Item Name: AS350/AS355 Quick Release Basket/Long Cargo Tube Mounting Provisions, Fits LH/RH

DART SERVICE INSTRUCTION

TO AMEND INSTALLATION INSTRUCTIONS D350-607-3 Rev.D,
INSTALLATION INSTRUCTIONS D350-607-4 Rev. C AND
INSTRUCTIONS FOR CONTINUED AIRWORTHINESS ICA-D350-607 REV. 6
REF TCCA STC: SH94-14
REF FAA STC: SR00213NY
REF EASA STC: EASA.10016996
REF BRAZILIAN STC: 2007S03-03/-04/-05/-06

A	NEW ISSUE	AJS	14.05.16
REV.	DESCRIPTION	BY	DATE
DESIGN	AJS	DART AEROSPACE LTD	
DRAWN	AJS	HAWKESBURY, ONTARIO, CANADA	
CHECKED		DRAWING NO.	REV. A
MFG. APPR.	N/A	DSI 9699	SHEET 1 OF 2
APPROVED		TITLE	SCALE
DE APPR.		LUG REPLACEMENT	NTS
DATE	14.05.16	COPYRIGHT © 2014 BY DART AEROSPACE LTD THIS DOCUMENT IS PRIVATE AND CONFIDENTIAL AND IS SUPPLIED ON THE EXPRESS CONDITION THAT IT IS NOT TO BE USED FOR ANY PURPOSE OR COPIED OR COMMUNICATED TO ANY OTHER PERSON WITHOUT WRITTEN PERMISSION FROM DART AEROSPACE LTD.

FIGURE 1: INSTALLATION OF D4775-041 FWD STRUT

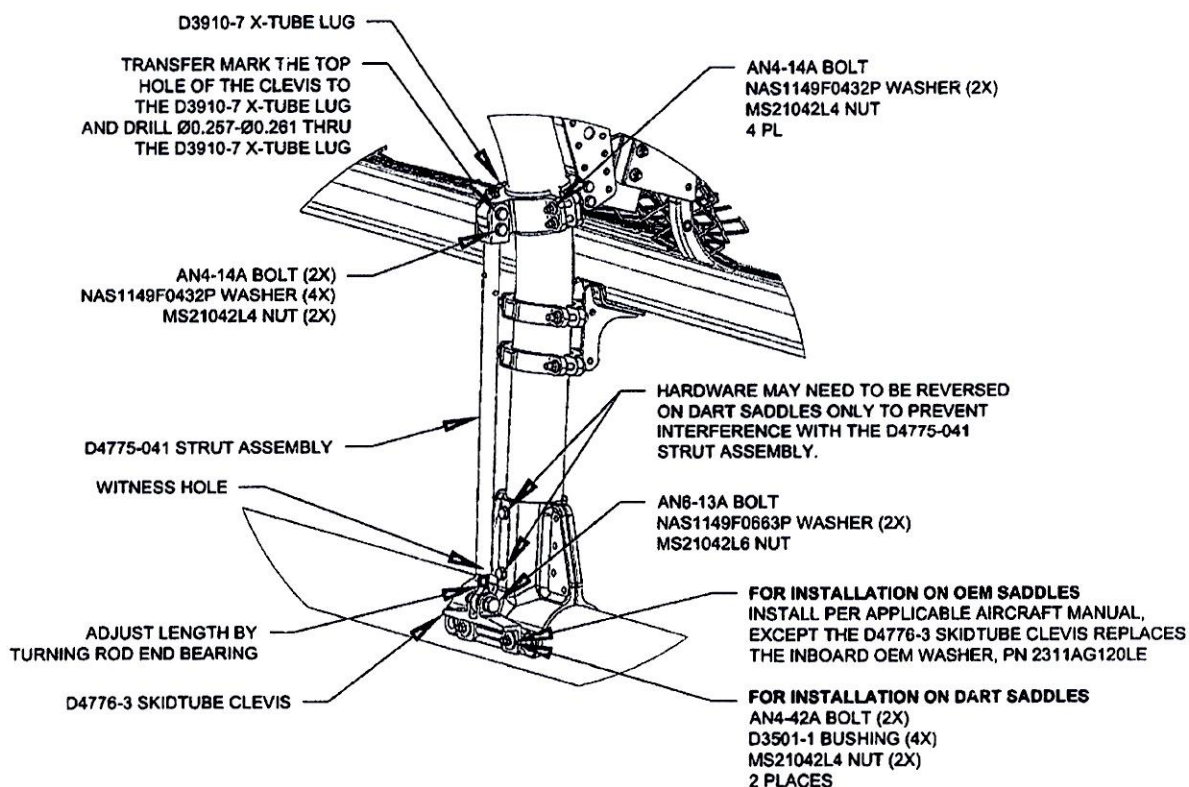
3.1 Substitute the Forward Lower D3910-5 X-Tube Lug with the D3910-7 X-Tube Lug as shown in Figure 1.

3.2 Install the forward D4775-041 Strut Assembly. Transfer mark from the upper hole on the clevis of the D4775-041 Strut Assembly to the D3910-7 X-tube Lug and drill thru the lug $\varnothing 0.257$ - $\varnothing 0.261$ as shown in Figure 1. Touch up chemical conversion coating per MIL-DTL-5541. Check the witness holes located at the bottom end of the D4775-041 Strut Assemblies to ensure that the thread from the rod end extends past the witness hole.
Torque MS21042L4/-4 nuts to 50-70 in-lbs (5.7-7.9 N-m). Torque MS21042L6/-6 nuts to 160-190 in-lbs (18.1-21.5 N-m).
